Access Compliance Report

Public Rights-of-Way

(Curb Ramps)

Intersection ID: 19210	Main Street: TYVOLA_RD	Cross Street: FARMBROOK_DR	Location: NW
ADA ID: 1147223B113B	Ramp Type: Perp	Initial Pass/Fail: Fail	Overall Compliance: No
		Severity Score: 8.75	
Codes/Mitigation Info/Possible Solution		Field Measurements/Component Compliance

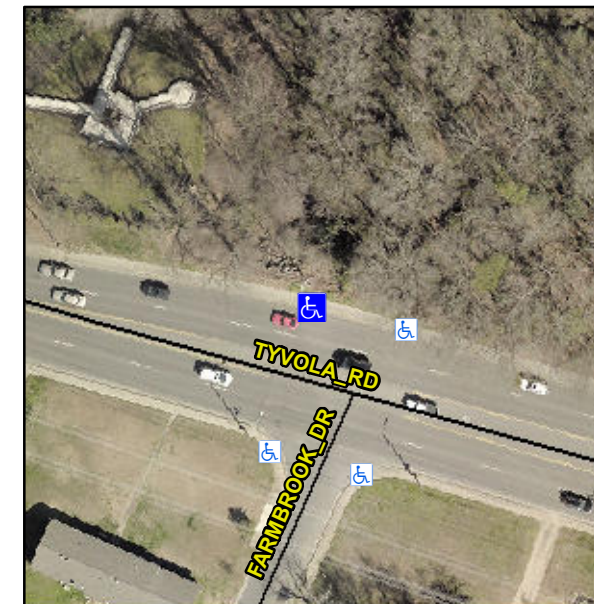
Not Found, R304.5.1

Compliance	Description	Data	Compliance	Description	Data
N/A	Ramp Length (in)	60.0	Yes	Ramp Slope (%)	5.6
No	Ramp Width (in)	36.0	Yes	Ramp XSlope (%)	1.2
N/A	Flare Type LT	N/A	N/A	Flare Type RT	N/A
N/A	Flare Slope LT (%)	N/A	N/A	Flare Slope RT (%)	N/A
N/A	Flare Traversable LT?	N/A	N/A	Flare Traversable RT?	N/A
N/A	Landing Length (in)	N/A	N/A	DWS Provided?	N/A
N/A	Landing Width (in)	N/A	N/A	DWS Contrast?	N/A
N/A	Landing Slope (%)	N/A	N/A	DWS Length (in)	N/A
N/A	Landing X Slope (%)	N/A	N/A	DWS Full Width?	N/A
N/A	Landing Curb? (Y/N)	N/A	N/A	DWS Offset (in)	N/A
N/A	Shared Landing?	N/A			
N/A	Gutter Ponding?	N/A	N/A	Gutter Slope (%)	N/A
N/A	Gutter Lip Ht (in)	N/A	N/A	Gutter X Slope (%)	N/A
N/A	Painted X Walk1?	No	N/A	Painted X Walk2?	N/A
	X Walk 1 Direction	To S		X Walk 2 Direction	N/A
N/A	X Walk 1 Width (in)	N/A	N/A	X Walk 2 Width (in)	N/A
	X Walk 1 Slope (%)	1.2		X Walk 2 Slope (%)	N/A
	X Walk 1 X Slope (%)	1.8		X Walk 2 X Slope (%)	N/A

Remove & Replace Entire Ramp.
